UNITED STATES PATENT AND TRADEMARK OFFICE

APPLICATION NO.	FILING DATE	FIRST NAMED INVENTOR	ATTORNEY DOCKET NO.	CONFIRMATION NO.
10/081,928	02/20/2002	Isreal Hicks	HICKS-1-1002	2184

Office Action Summary

DETAILED ACTION

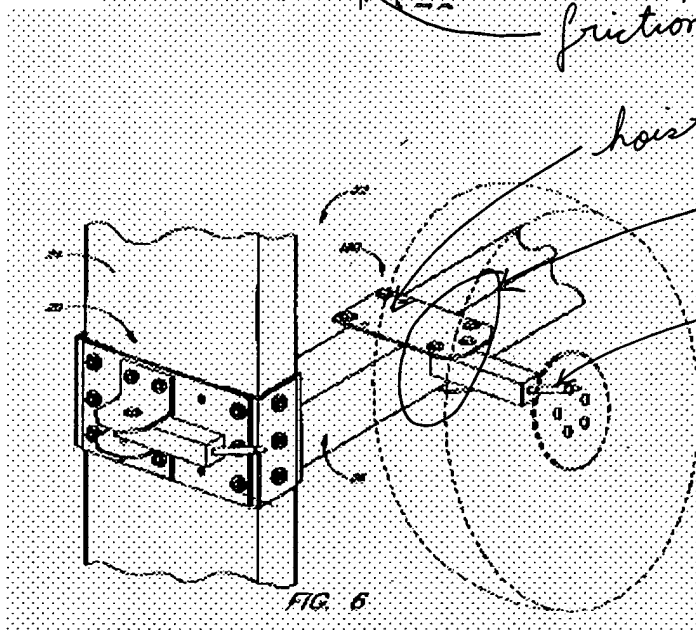
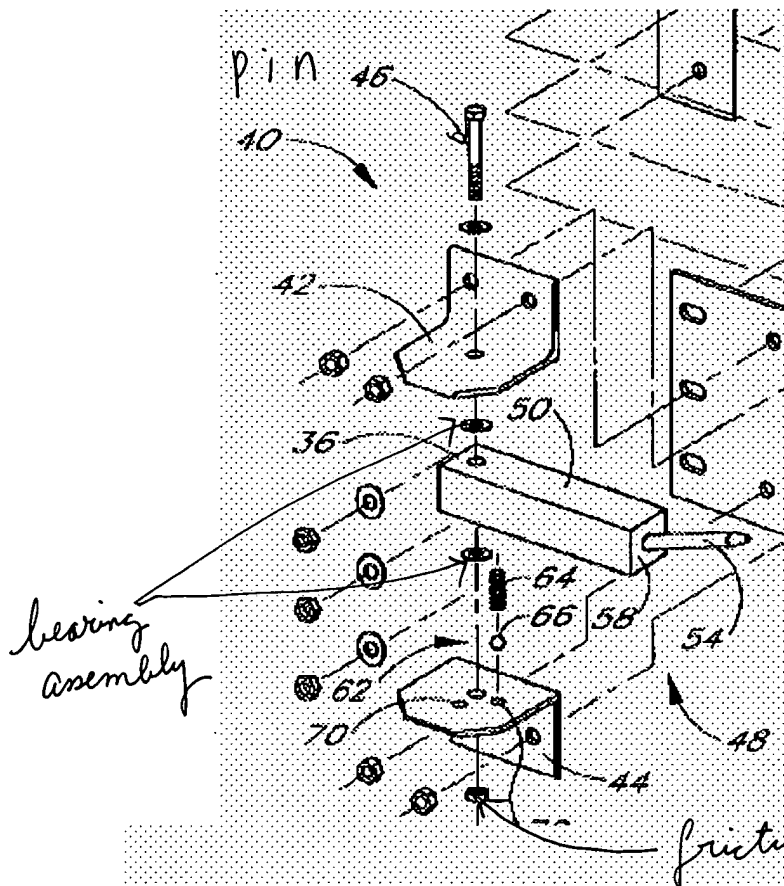
Claims 21-25, 30-32, 38, 39, and 41-47 are rejected under 35 U.S.C. 102(b) as being anticipated by Starling et al (WO 00/55031). Starling discloses a tire hanger (120, see illustration below) comprising a hoist wrap section having an open end arranged to removeably engage to the horizontal support member of a vehicle hoist; a tire hanging section arranged to engage axle of a wheel; and a middle section disposed between the hoist wrap section and the tire hanging section wherein the middle section having a length and having an articulated joint, whereby the hoist wrap section is shaped so as to wrap around the horizontal support member of the vehicle hoist. Further, Starling's hoist wrap is inherently can be slidably positionable along the horizontal support member at a user-selected a location when the nuts are loosened. Starling also further discloses the pivot joint includes a bearing assembly (see illustration below), a pin (46, figure 2), and a frictional locking device (nut).
